FINAL ENVIRONMENTAL ASSESSMENT FOR THE LUDEMAN
SATELLITE IN SITU RECOVERY PROJECT,
CONVERSE COUNTY, WYOMING

DOCKET NO. 40-8502

August 2018

Figure 2-1. Conceptual Site Layout of the Ludeman ISR Satellite Project (Uranium One, 2017e)

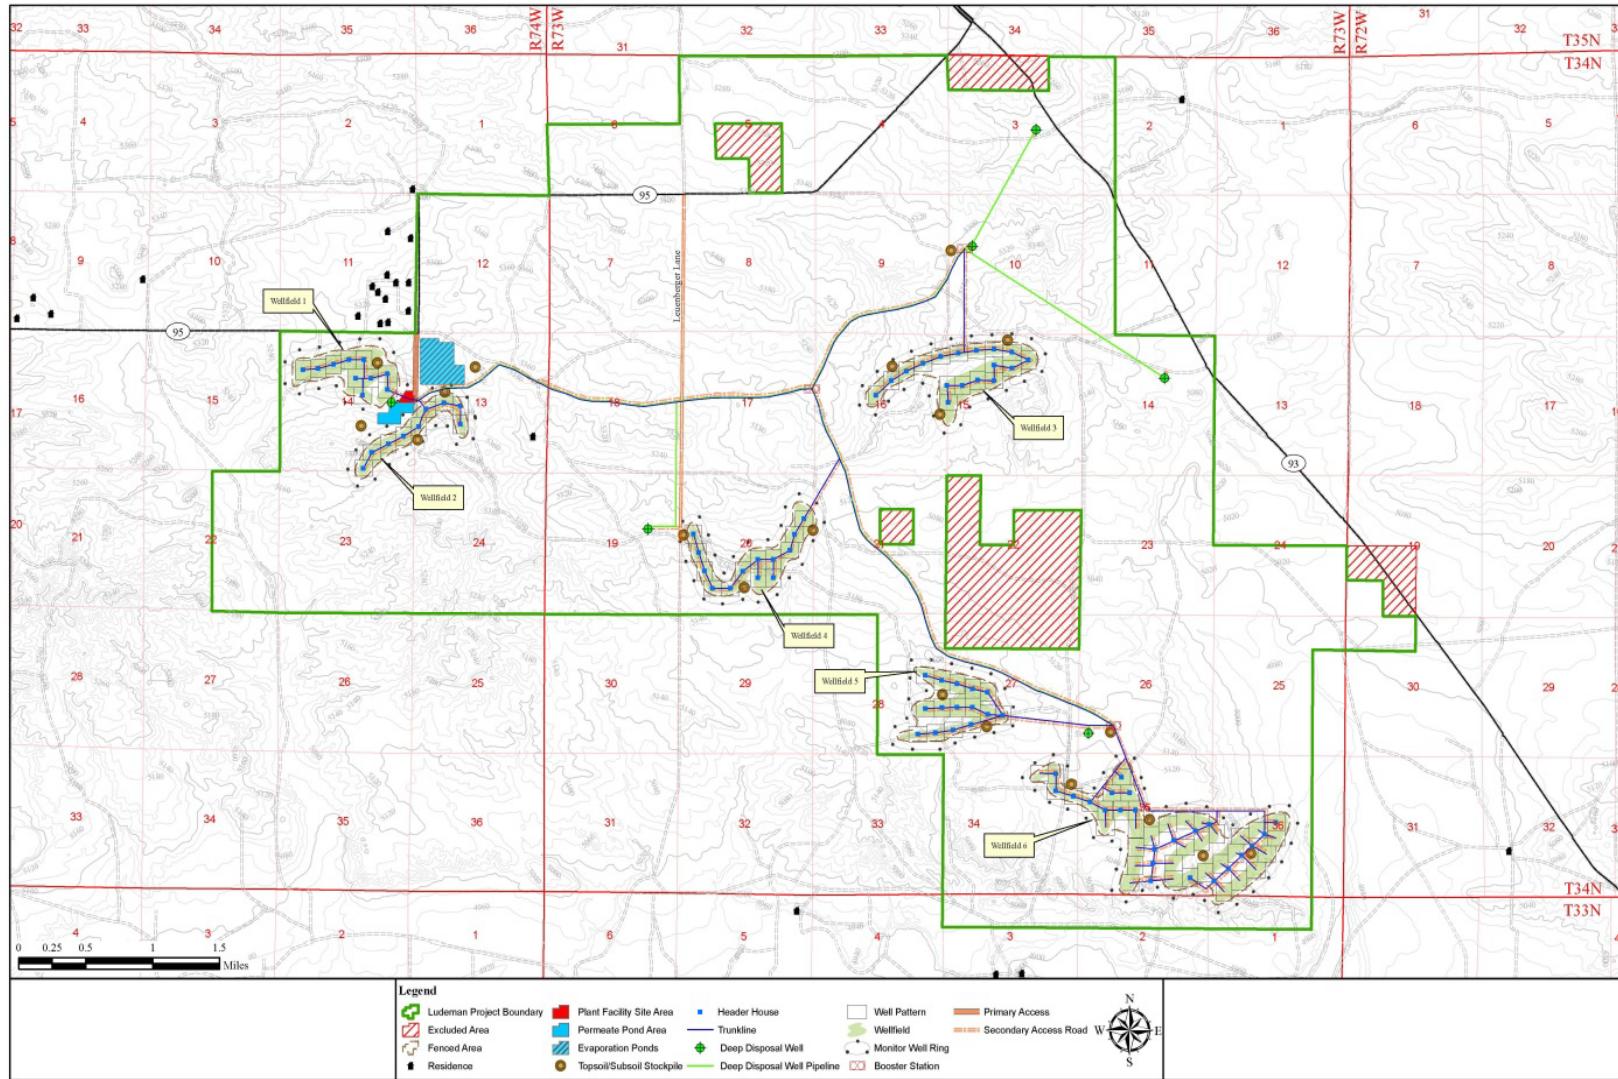
“Figure 2-1, Conceptual Site Layout of the Ludeman ISR Satellite Project, page 2-5. This map is very difficult to read due to the font size and very small features on the map. It is suggested that the map be revised to either enlarge the font or configure the map to be divided up into sections.”

Response: *The NRC acknowledges that EA Figure 2-1 is difficult to read because of the font size and very small features. Figure 2-1 was revised to enlarge the font size and resized to improve its readability.*

Figure 2-2. Proposed Project Schedule for Ludeman ISR Satellite Project (Uranium One, 2017e)

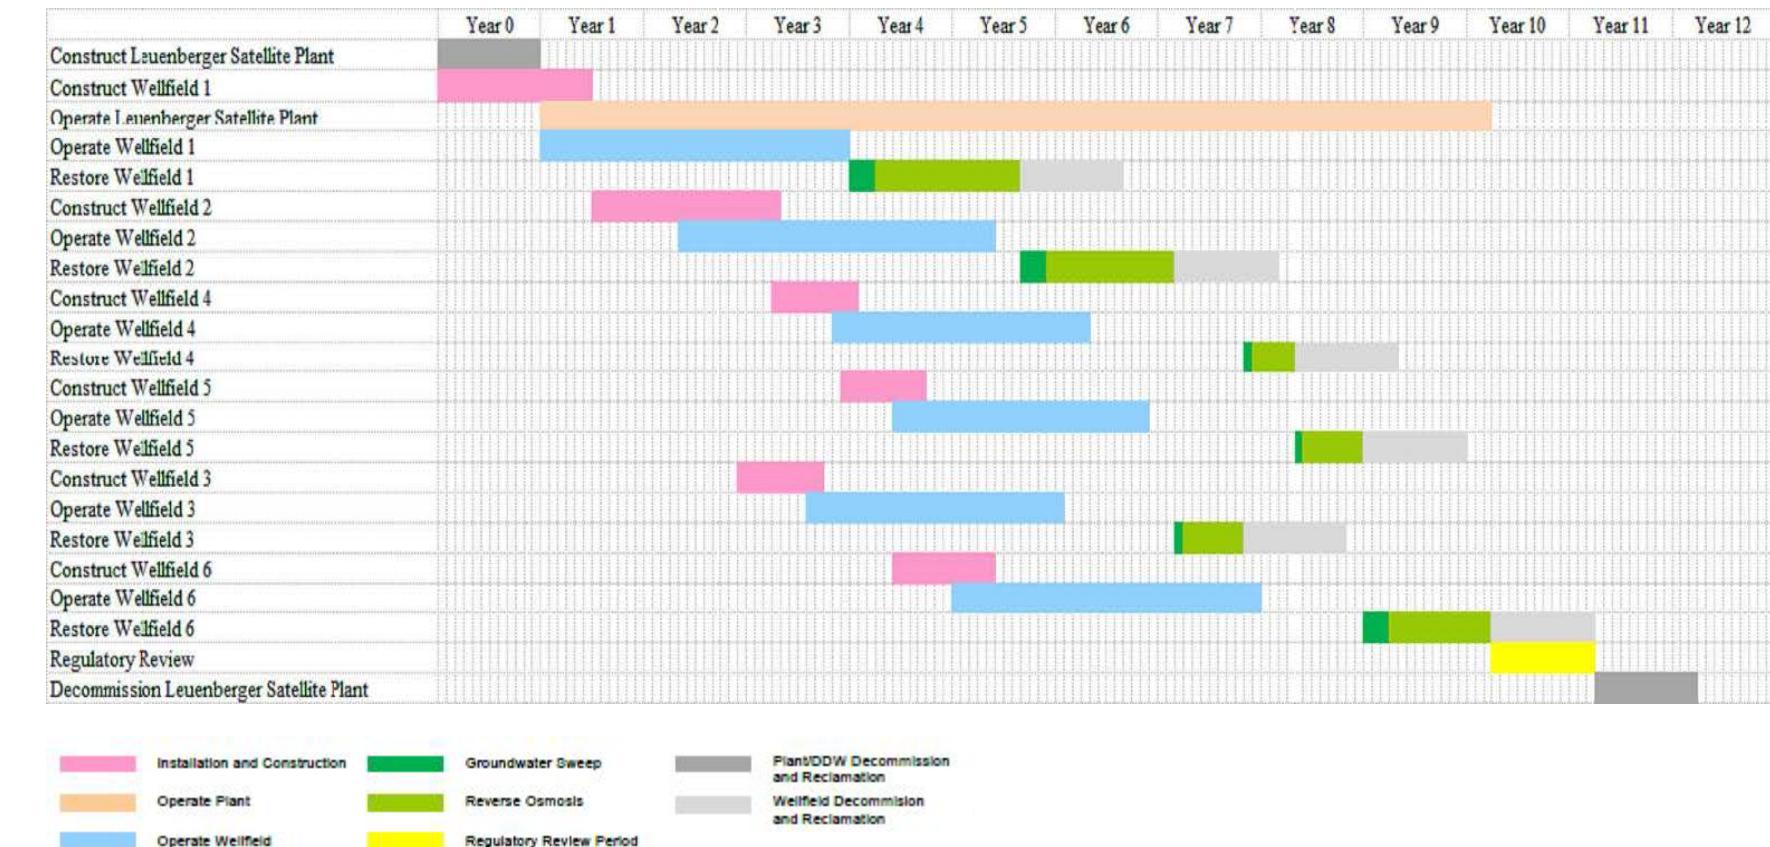
“Figure 2-2, Proposed Project Schedule for Ludeman ISR Satellite Project, page 2-6. As noted in Comment #6 above, the NRC has made a determination that Wellfield 2 will not be

Figure 3-2. Watersheds and Surface Water Features in the Proposed Ludeman ISR Project Area and 3.2-km [2-mi] Buffer (Modified from Uranium One, 2017d)

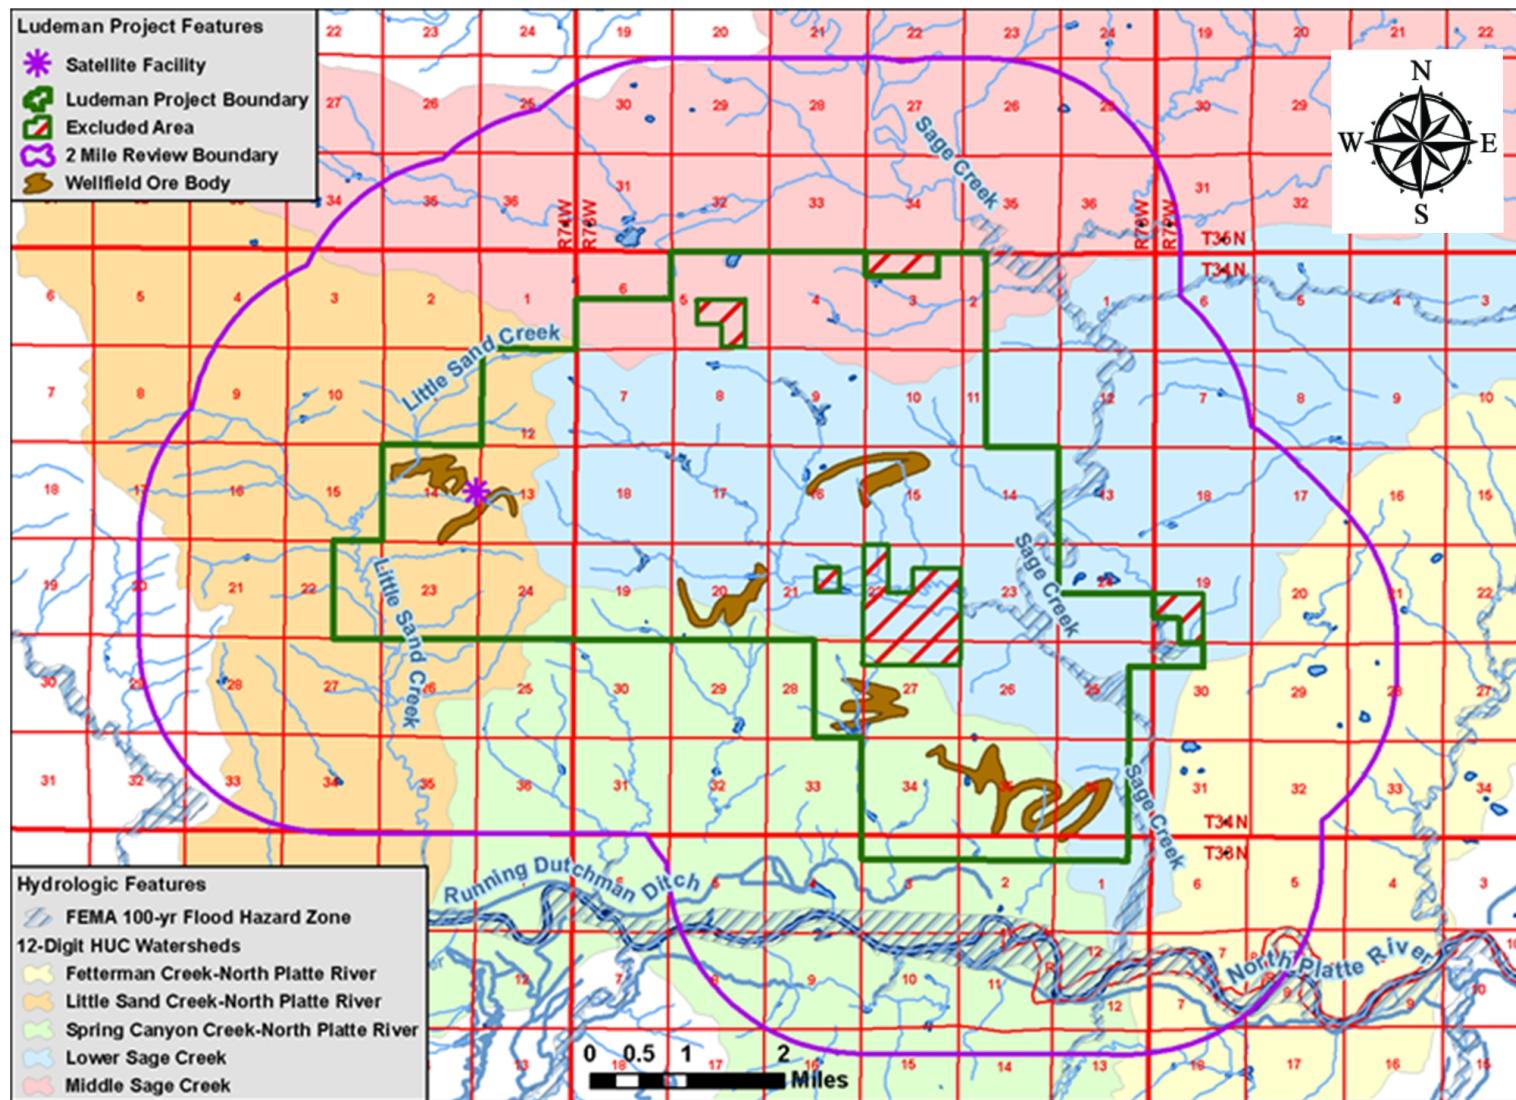
“Figure 3-2, Watersheds and Surface Water Features in the Proposed Ludeman ISR Project Area and 3.2 km (2 mi) Buffer, page 3-14. This map does not have a north arrow and should be added to the figure.”

Response: The NRC agrees with the comment. A north arrow was added to EA Figure 3-2.

Figure 3-3. Subwatersheds, Surface Water Features, FEMA 100-year Flood Hazard Zones, Surface Water Rights and Sampling Locations at the Proposed Ludeman ISR Project (Modified from Uranium One, 2017d).

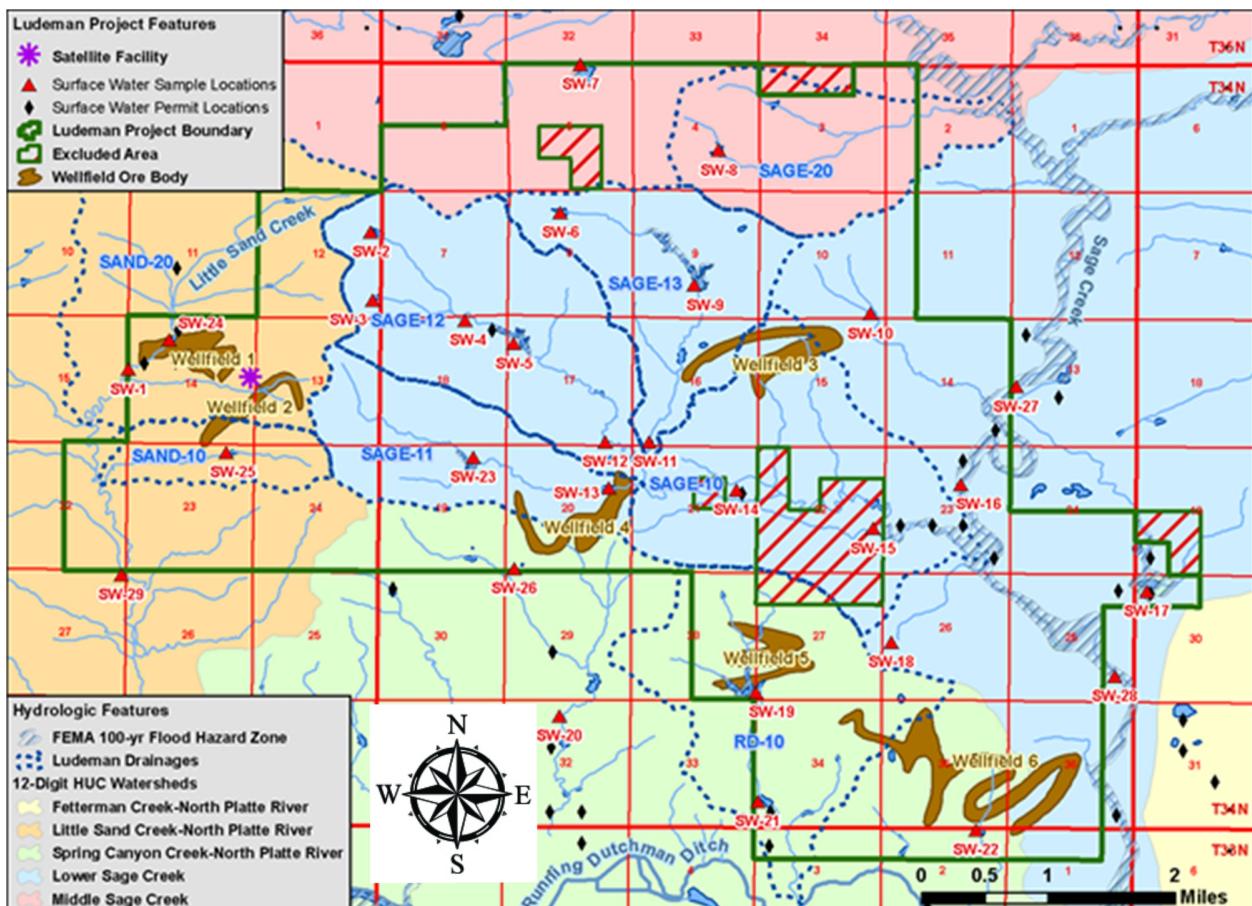
“Figure 3-3, Subwatersheds, Surface Water Features, FEMA 100-year Flood Hazard Zones, Surface Water Rights and Sampling Locations at the Proposed Ludeman ISR Project, page 3-16. This map does not have a north arrow and should be added to the figure.”

Response: The NRC agrees with the comment. A north arrow was added to EA Figure 3-3.
